Subject: MHI's Responses to US-APWR DCD RAI No. 850-6002 Revision 3 (SRP 03.07.01)

Responses to Request for Additional Information No. 850-6002, Revision 3

US-APWR Design Certification Mitsubishi Heavy Industries Docket No. 52-021 RAI NO.: NO. 850-6002 REVISION 3 SRP SECTION: 03.07.01 – Seismic Design Parameters APPLICATION SECTION: 3.7.1 DATE OF RAI ISSUE: 10/21/2011

Figure 1 – Regions of Marcellus and Devonian Shales

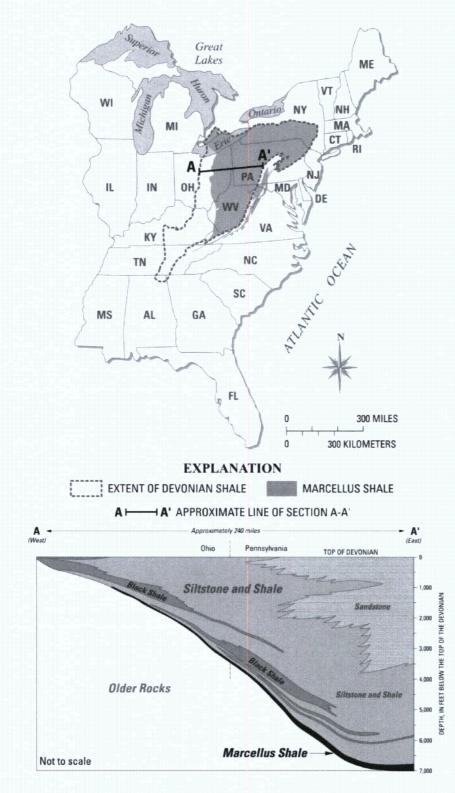
Section 4.2 of MUAP-10001(R3), "Development of Soil Profiles and Strain Compatible Properties" (Page 4-5) states that a whole new suite of soil properties were developed for the new seismic analysis reported herein. The last two sentences in the first paragraph states, "The number of available profiles generally decreases rapidly with depth as noted in "Surface Geology Based Strong Motion Amplification Factors for the San Francisco Bay and Los Angeles Areas" (Reference 7). Therefore, judgment has to be used to extend the generic profiles at the deeper depths."

The staff believed that the US-APWR seismic analyses are to be applicable to a large number of sites in the Central and Eastern United States (CEUS), nonetheless, the reference cited (Reference 7) is meant for the Western US regions (specifically California). The Applicant is requested to explain: (1) how the material in Reference 7 in MUAP-10001(R3) is applied to the CEUS sites; and (2) describe the nature, extent, and the basis of the judgment that was necessary to determine the soil profiles that are applicable to and representative of the CEUS sites.

The reference cited (Reference 7 of Technical Report MUAP-10001 (R3)) illustrates the process of developing a generic soil profile as an average of multiple measured profiles in this case within similar surficial geology. Reference 7 also clearly illustrates how the number of measured profiles decrease with increasing depth and the judgment process of extending the average to depths where only few profiles exist as well as deeper, where the shallow gradient is used to guide the extrapolation. An additional reference is Silva (1997) (Reference 3) where a similar process is illustrated to develop generic profiles based on Geomatrix site categories, a well-known recording site categorization scheme. The cited references were to describe the process only, not the development of the generic DCD profiles. The development of generic profiles in this manner has been validated by modeling recorded motions at over 500 sites from about 15 earthquakes using the generic profiles (EPRI, 1993, Reference 1; Silva et al., 1996, Reference 2; Silva, 1997, Reference 3) for sites worldwide. Because geologic processes do not change at 105° W longitude in the US and Canada, profiles and G/G_{max} and hysteretic damping curves are generally

similar between western North America (WNA) and central and eastern North America (CENA). Sands, clays, and graves, Holocene soils, Pleistocene soils, soft, firm, and hard rock sites have similar dynamic material properties between WNA and CENA as well as worldwide. It is only the relative distributions that differ. For example, there are loess and till sites in both WNA and CENA but they cover a relatively larger area in CENA. There are glacially showered sites in WNA and CENA but again more widespread in the CENA. Hard rock sites as well as hard rock beneath soils exist in WNA but is much more common in CENA. Residual soils and saprolite exist across the U.S. but more common in CENA. As a result generic G/G_{max} and hysteretic damping curves are used worldwide and are not specific to any particular tectonic regime. The same tectonic independence applies to velocity profiles with the exception of the differences in the occurrence of hard basement rock between WNA and CENA. Hard basement rock beneath soils is more prevalent in the CENA than WNA which was the motivation for developing ground motion prediction equations (GMPEs) for hard rock outcrops (i.e., $V_s = 2.83$ km/sec) for the CENA (EPRI, 1993, Reference 1; 2004, Reference 4). However there are also large regions across the CENA with significantly lower velocity sedimentary rock beneath the soils. The area comprising the Gulf Coast (EPRI, 1993, Reference 1) as well as the large region of the gas bearing Marcellus and Devonian shales (Figure 1 below), with both regions comprising a significant portion of the CENA, have sedimentary rock comprised of siltstones, sandstones, mudstones, shales, and some limestones underlying the soils. Put another way, one cannot look at velocity profile and determine conclusively whether it is from WNA, CENA, Taiwan, Japan, Turkey, etc. If it is a soil profile and the underlying rock has a shear-wave velocity exceeding about 2.0 km/sec, it likely reflects a CENA location. If, on the other hand, there is a steep velocity gradient beneath the soil, the profile may be from WNA or CENA. For applications to a DCD the issue of significance is whether the distribution in profile stiffness and depth reflects an acceptable range in column frequencies as depicted in Technical Report MUAP-10001 (R4) Figure 5.2-15. This was the underlying motivation in profile development and final selection.

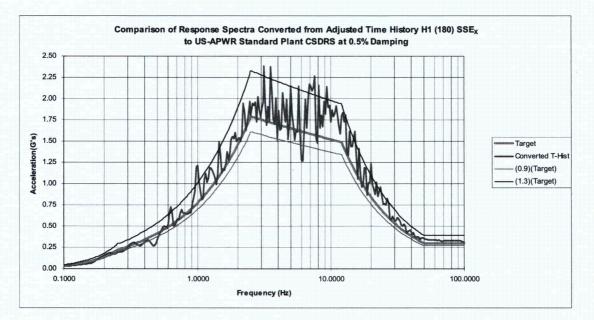
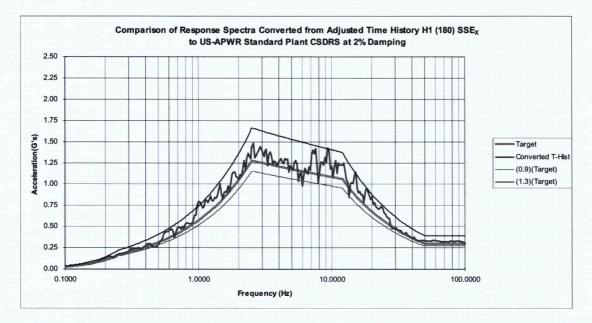
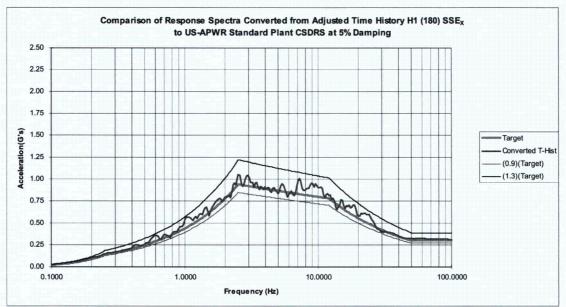
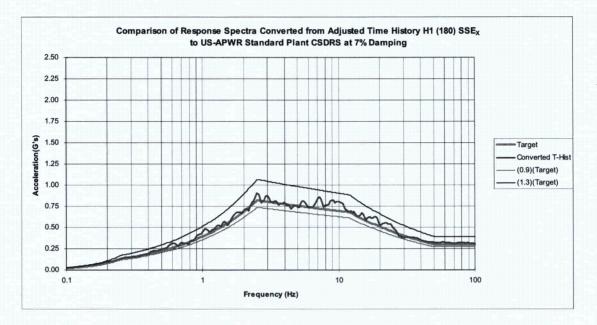
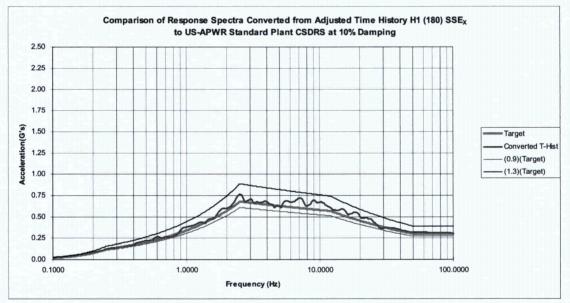
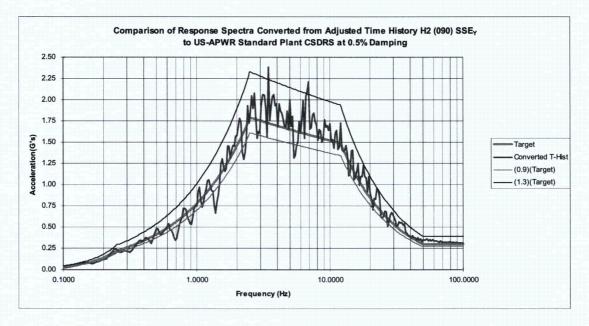
In Subsection 4.1 of MUAP-10001(R3), "CSDRS Compatible Ground Motion Time Histories," Item 2 of the first paragraph on Page 4-4 states:

- "a. Run RSPMatch to simultaneously match the target for the five damping ratios defined in the target and multiple iterations.
- b. Apply baseline correction to the matched time history motion.
- c. Rerun RSPMatch to match only the 5% damped spectral target, only with a single iteration.
- d. Apply baseline correction to that time history motion."

It is a general engineering practice that the spectrum from the artificial ground motion time history must envelop the free-field design response spectra for all damping values used in the seismic response analysis. The applicant is requested to clarify whether the time history obtained from step c stated above will simultaneously match the target spectra for the five damping ratios. The Applicant is also requested to provide graphical plots for the comparisons and to provide rationale for why step c is needed once step a is done.

Please see the response to similar questions in RAI 852-6003 Question 03.07.02-112. The selection of seed recorded ground motion to be used as the basis of time history ground motion for the CSDRS of the US-APWR is being further considered at this time to develop a response to the recently received questions of SEB1 RAI 6202 Revision 3.

Neither ASCE 4-06 nor ASCE 43-05 contains a provision that the spectrum from the artificial ground motion time history must envelop the free-field design response spectra for all damping values used in the seismic response analysis. Also, this practice has generally not been applied when developing time histories to represent the site-specific input ground motion that is

developed at each site in COL Applications. Therefore MHI understanding is that it has not been a general engineering practice that the spectrum from the artificial ground motion time history must always envelop the free-field design response spectra for all damping values used in the seismic response analysis. In fact, this issue is only recently being studied (see reference cited below). The re-generated time histories for the US-APWR are generated in accordance with the guidance of option 1 approach 2 of SRP 3.7.1 (R3). Unlike the guidance for option 1 approach 1, option 1 approach 2 only requires envelop of the computed 5% damping response spectrum of the accelerogram (see items ii.c and ii.d of the SRP). The time histories obtained from step c referred to in this RAI question do not simultaneously envelope the target spectrum for the other four of the five damping ratios to the criteria of the SRP. Baseline correction as part of the RSPMatch code process to achieve optimal convergence in a single iteration instead of multiple iterations to match the target damped response spectra alters the time history and its corresponding conversion to a response spectra such that step c is needed once step a is done to ensure matching of the final 5% damping.

(A) For "the BAL (Mt Baldy, CA) recording of the January 14, 1994, Northridge earthquake (magnitude M6.7), comparisons between the CSDRS spectra presented in Technical Report MUAP 10001 (R3) and the spectra generated from the artificial time histories are provided below for three component directions of each of the five damping ratios including 0.5%, 2%, 5%, 7%, and 10% damping:
